Access Compliance Report

Public Rights-of-Way

(Curb Ramps)

Intersection ID: 32231	Main Street: CAMBRIDGE_GREEN_DR	Cross Street: OXFORD_COMMONS_DR	Location: E
ADA ID: 3F21D855579D	Ramp Type: Perp	Initial Pass/Fail: Fail	Overall Compliance: No
Severity Score: 21.25			
Codes/Mitigation Info/Possible Solution		Field Measurements/Component Compliance

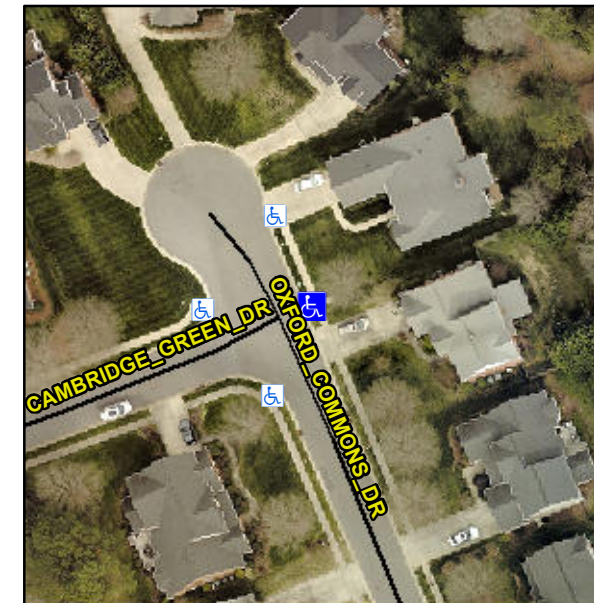
Not Found, R304.5.1, R304.2.2

Compliance	Description	Data	Compliance	Description	Data
N/A	Ramp Length (in)	48.0	No	Ramp Slope (%)	8.9
No	Ramp Width (in)	47.5	Yes	Ramp XSlope (%)	1.7
N/A	Flare Type LT	N/A	N/A	Flare Type RT	N/A
N/A	Flare Slope LT (%)	N/A	N/A	Flare Slope RT (%)	N/A
N/A	Flare Traversable LT?	N/A	N/A	Flare Traversable RT?	N/A
N/A	Landing Length (in)	N/A	N/A	DWS Provided?	N/A
N/A	Landing Width (in)	N/A	N/A	DWS Contrast?	N/A
N/A	Landing Slope (%)	N/A	N/A	DWS Length (in)	N/A
N/A	Landing X Slope (%)	N/A	N/A	DWS Full Width?	N/A
N/A	Landing Curb? (Y/N)	N/A	N/A	DWS Offset (in)	N/A
N/A	Shared Landing?	N/A			
N/A	Gutter Ponding?	N/A	N/A	Gutter Slope (%)	N/A
N/A	Gutter Lip Ht (in)	N/A	N/A	Gutter X Slope (%)	N/A
N/A	Painted X Walk1?	No	N/A	Painted X Walk2?	N/A
	X Walk 1 Direction	To NW		X Walk 2 Direction	N/A
N/A	X Walk 1 Width (in)	N/A	N/A	X Walk 2 Width (in)	N/A
	X Walk 1 Slope (%)	1.9		X Walk 2 Slope (%)	N/A
	X Walk 1 X Slope (%)	1.8		X Walk 2 X Slope (%)	N/A

Remove & Replace Entire Ramp.
